ADDENDUM NO. 1

TO: PLANS AND SPECIFICATIONS FOR STATE OF MISSOURI

Remodel Space for Printshop Utilization
Scruggs Station Warehouse
Jefferson City, Missouri
PROJECT No.: O2544-01

A-301

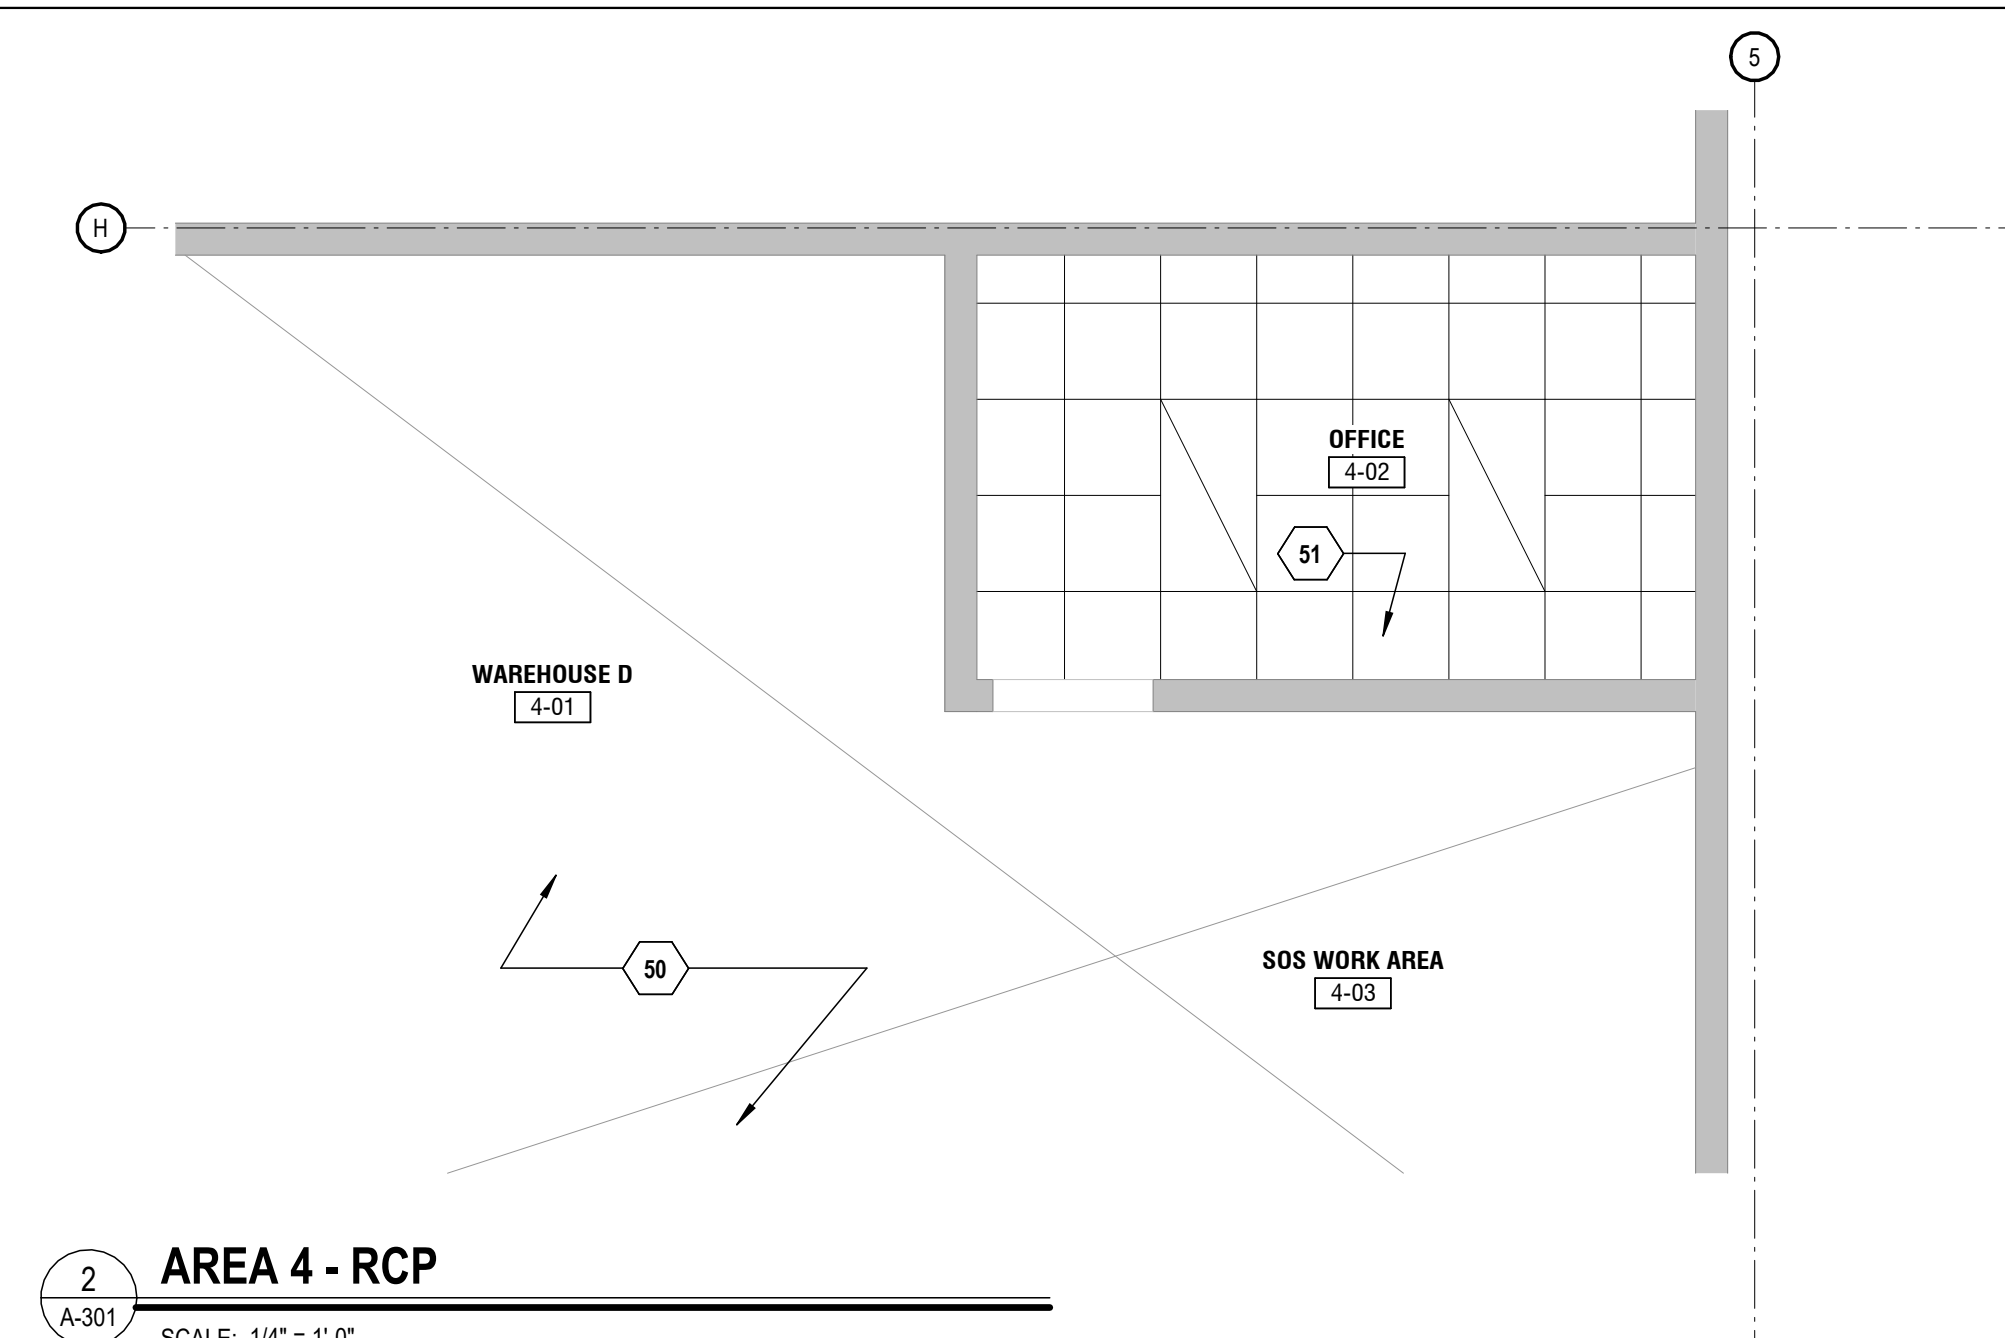
2. **Sheet A-301:** (full sheet re-issued)
 - a. Revised Keynote No. 4 : "Contractor to remove, salvage, and return existing steel framed warehouse storage racks to owner."

A-304

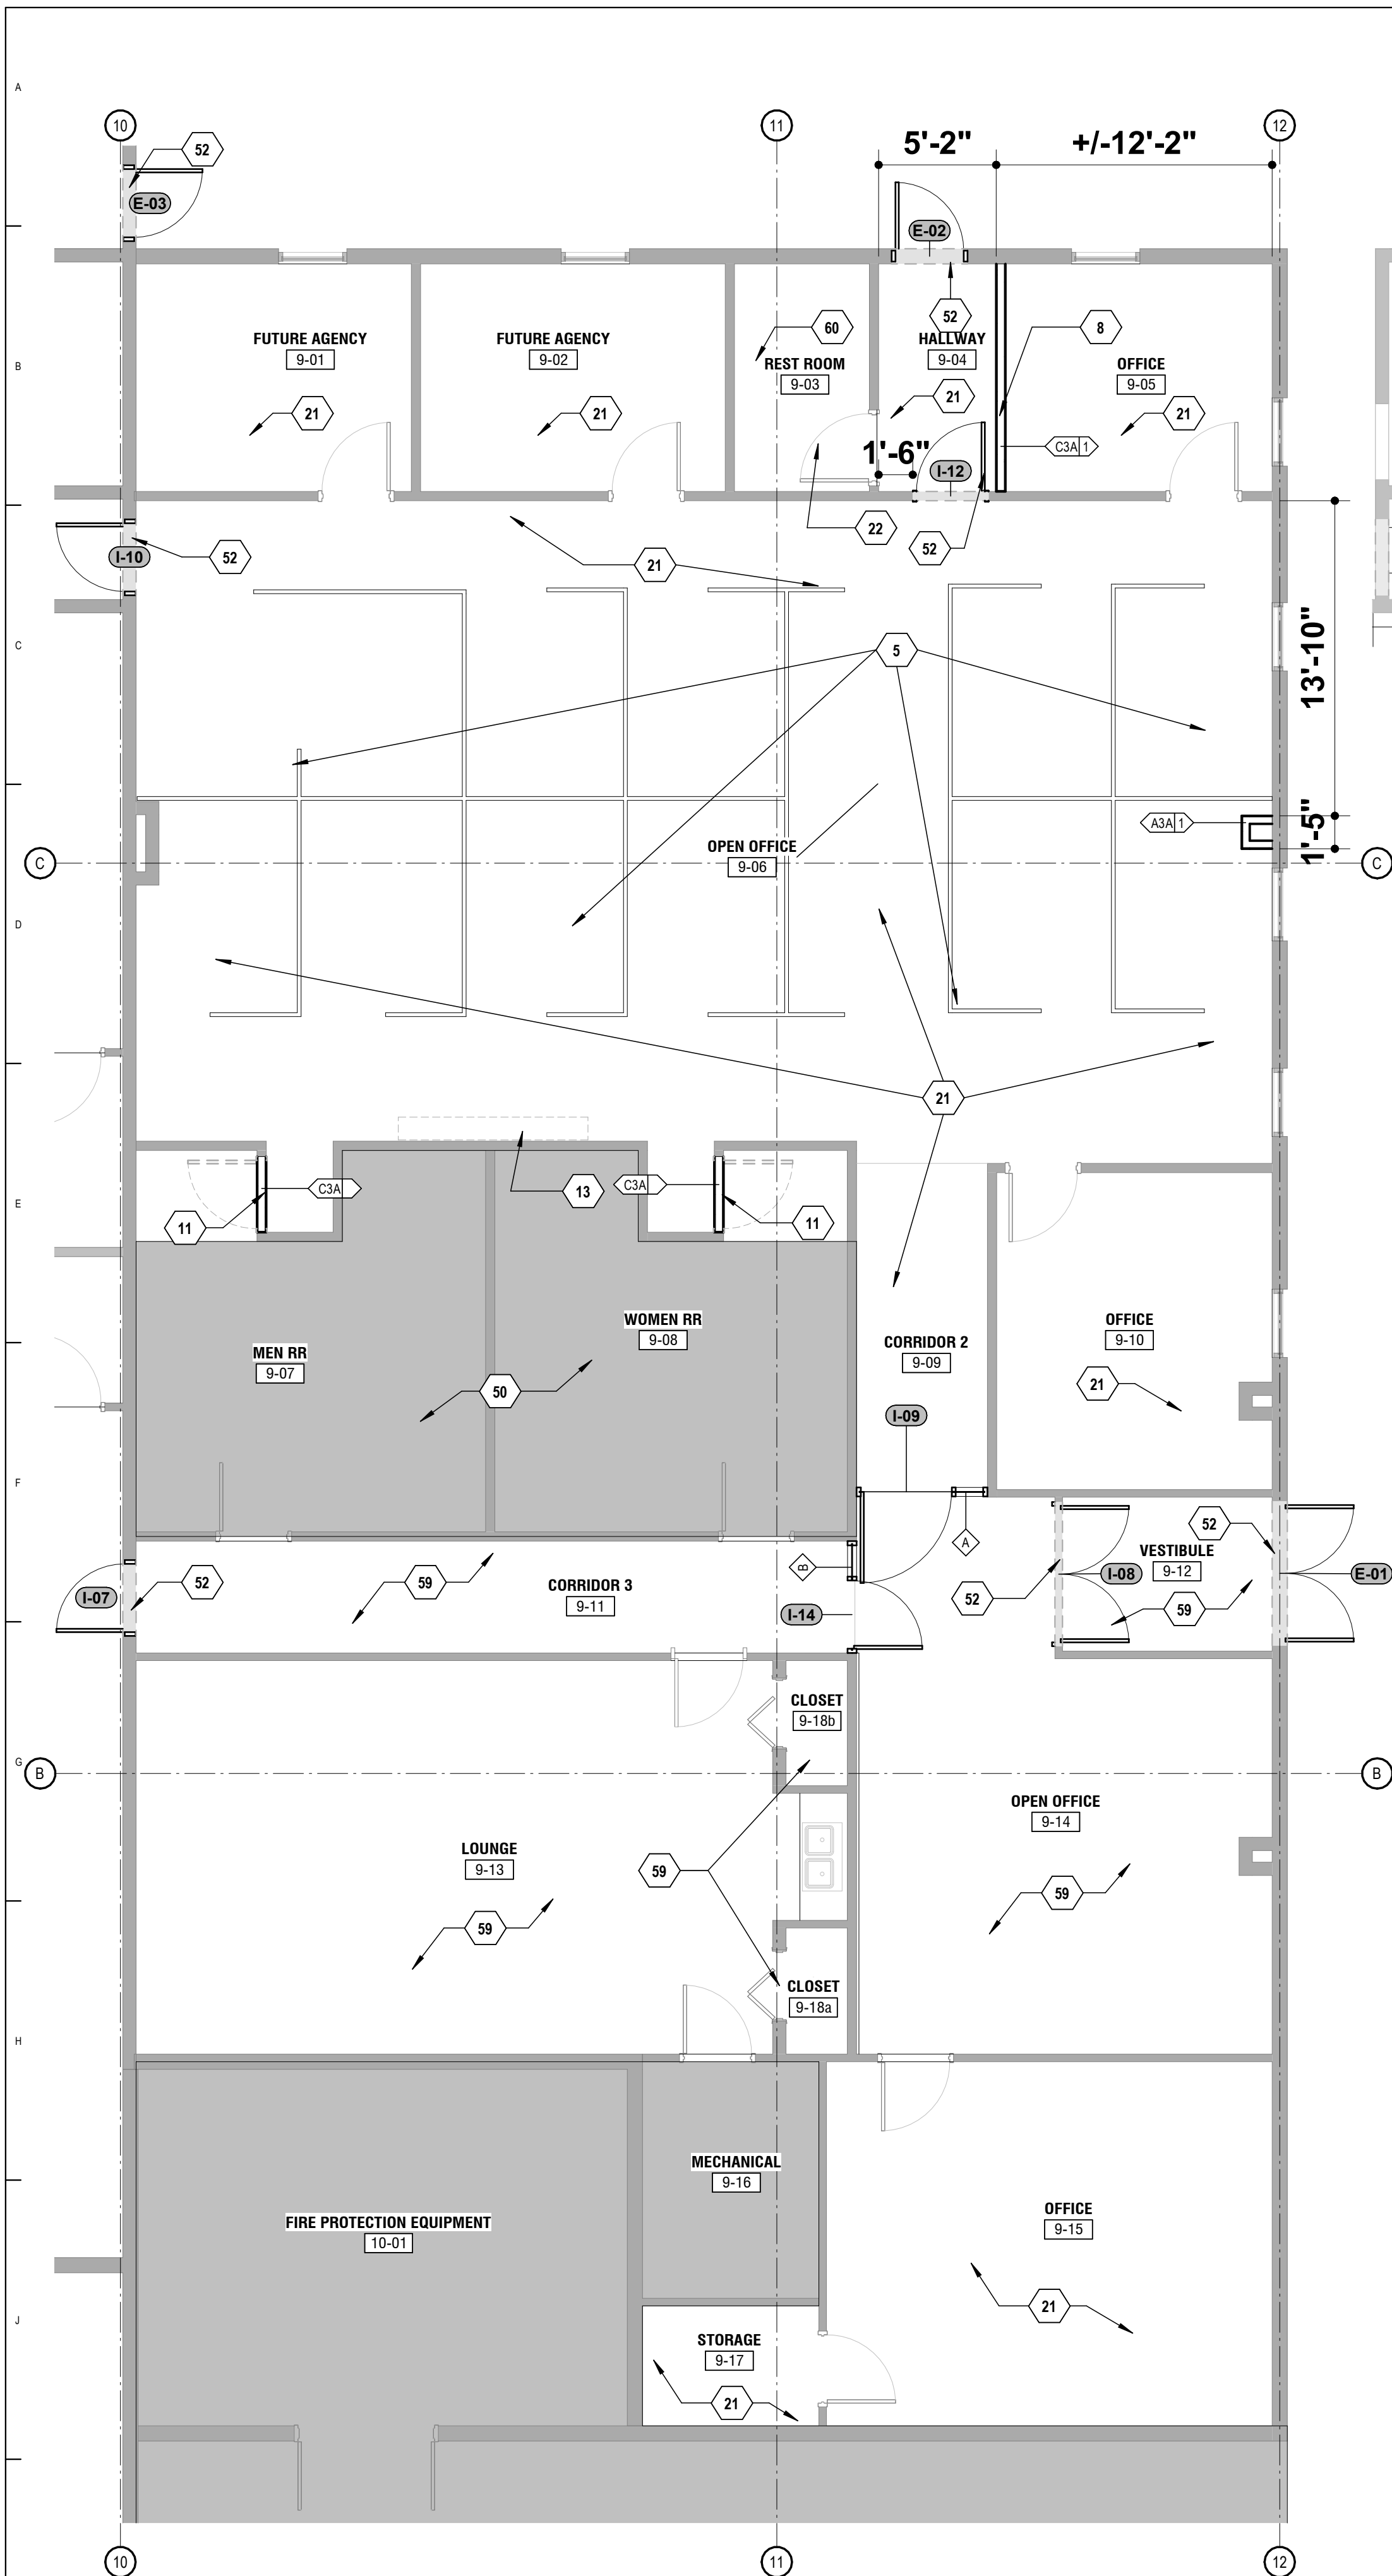
3. **Sheet A-304:** (full sheet re-issued)
 - a. Replace ACT Ceilings with new (C1) in Restroom 9-03, Hallway 9-04, and Office 9-05.
4. **Sheet A-501:** (full sheet re-issued)

A-501

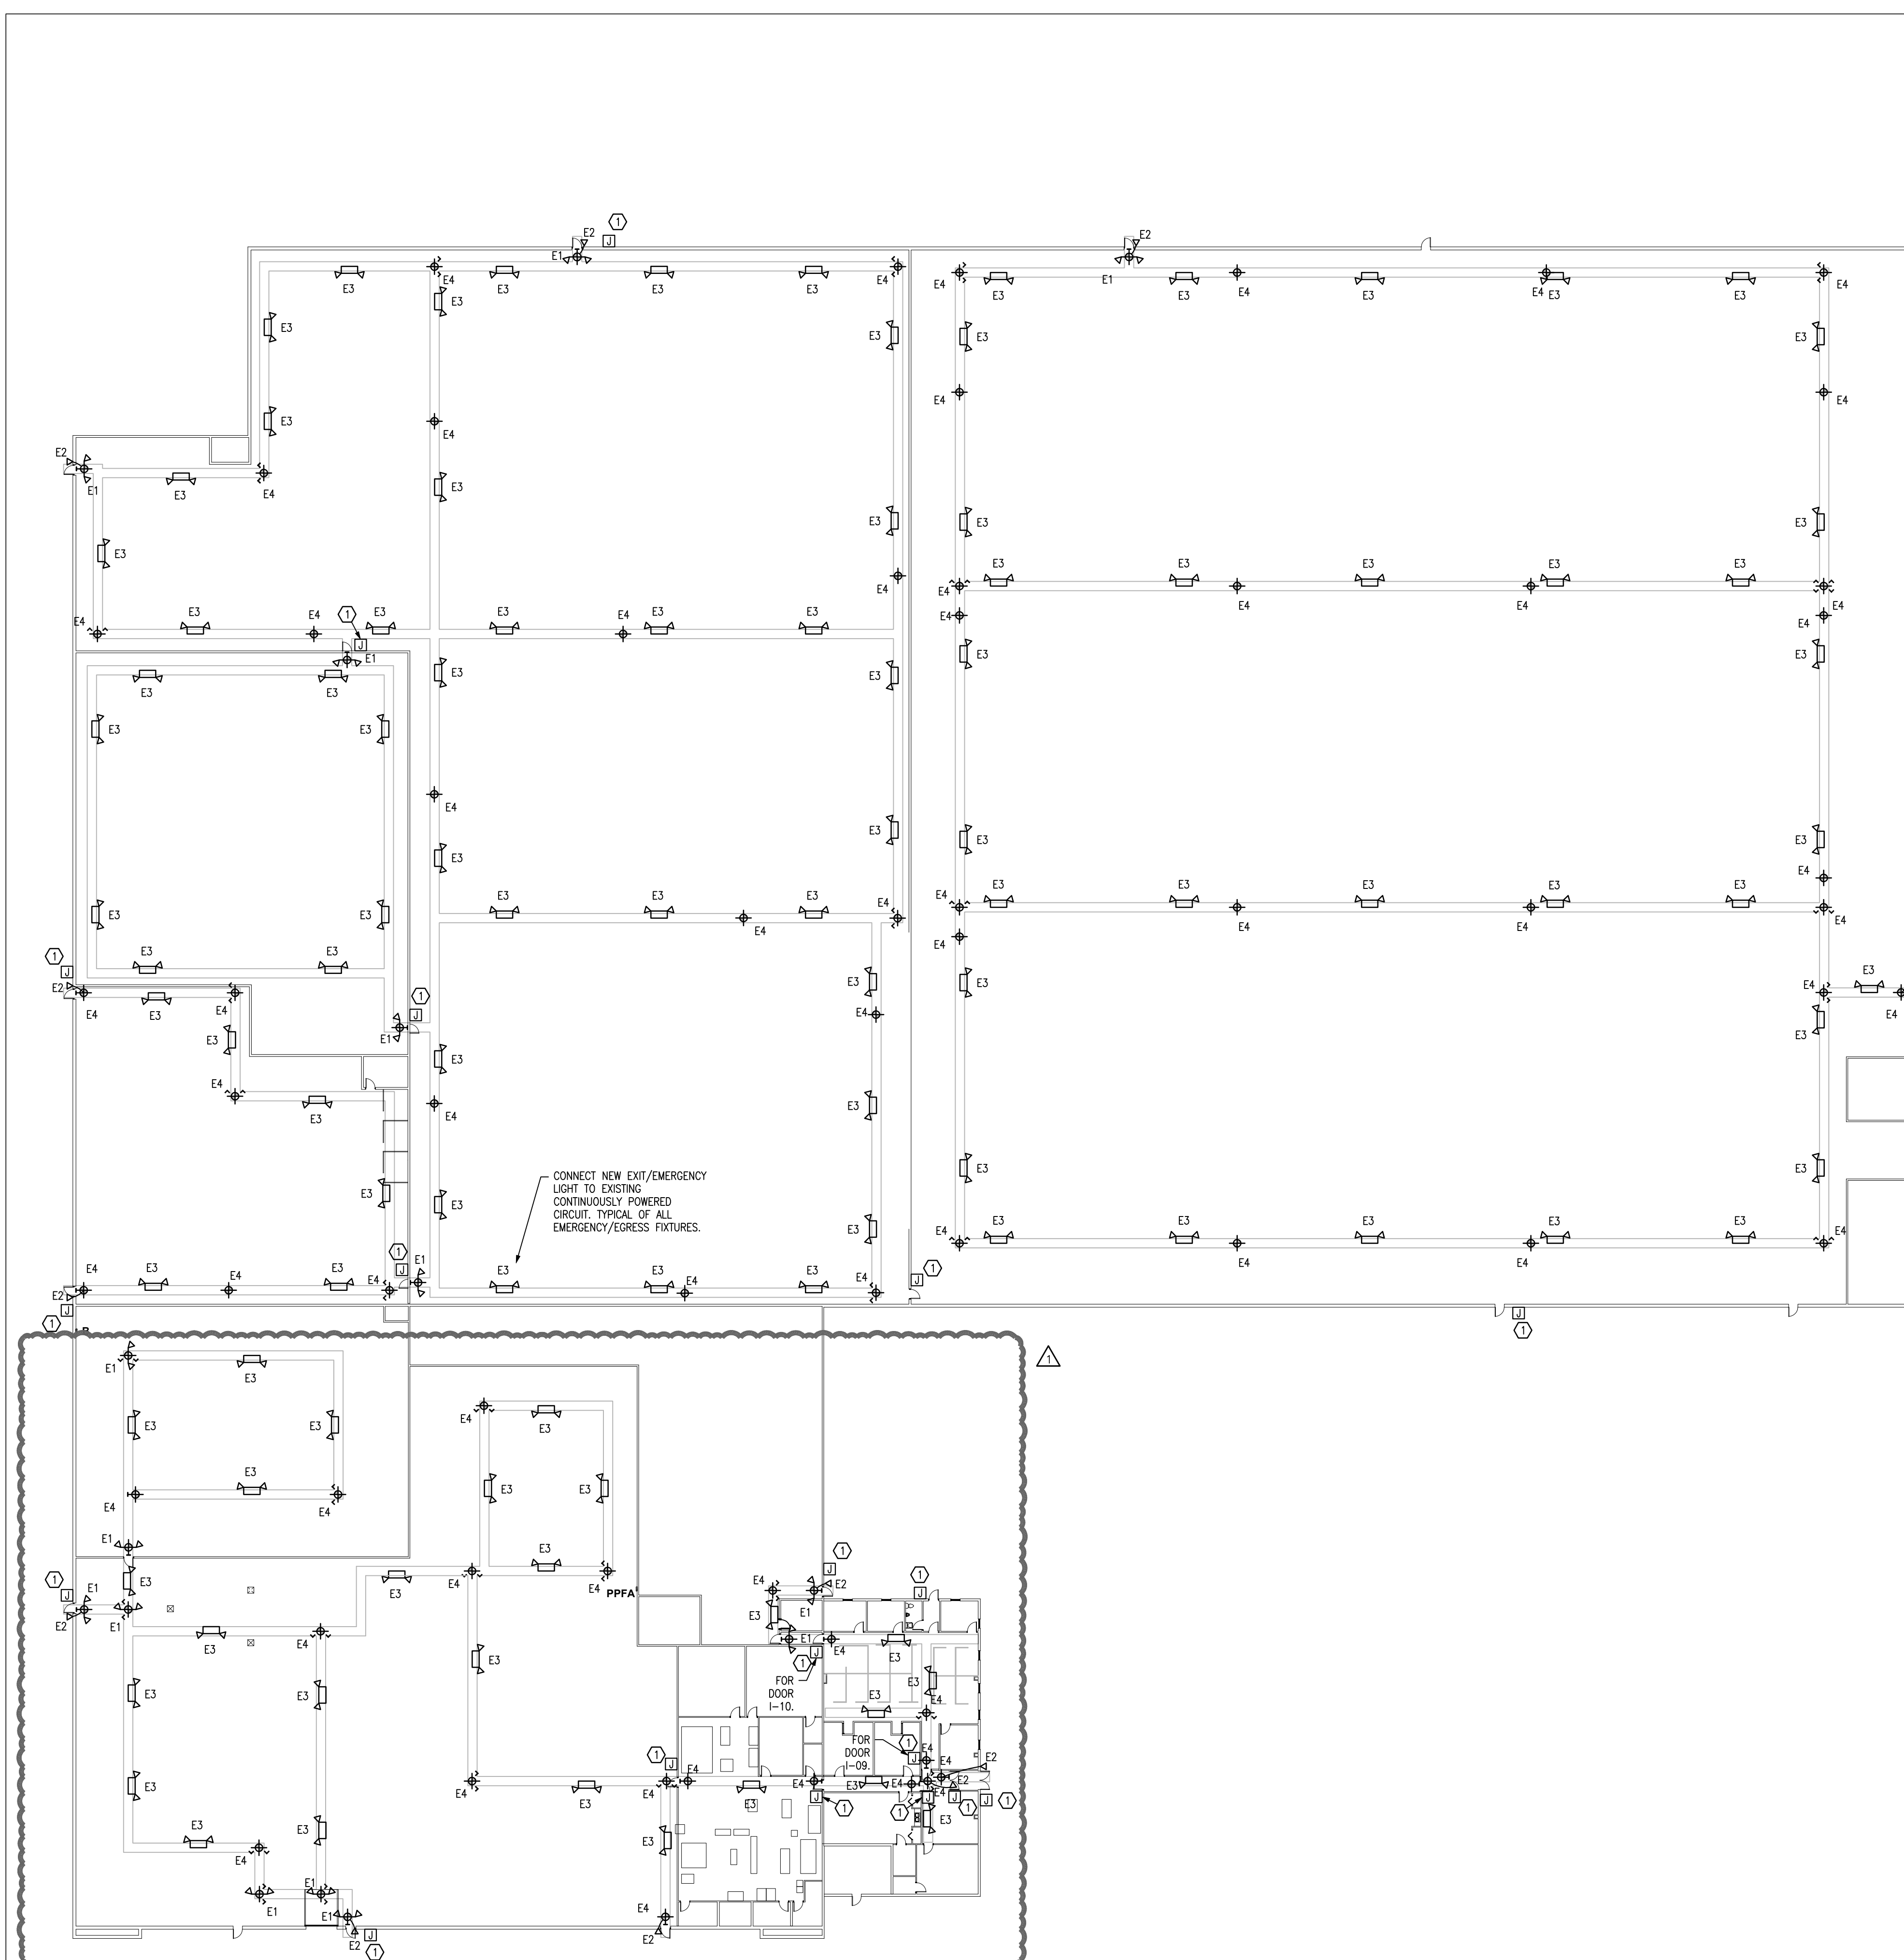
- a. Revised Door detail E11/A-501
5. **Sheet ME101:** (full sheet re-issued)
 - a. Updated overall floor plan background based on drawing changes made in Addendum
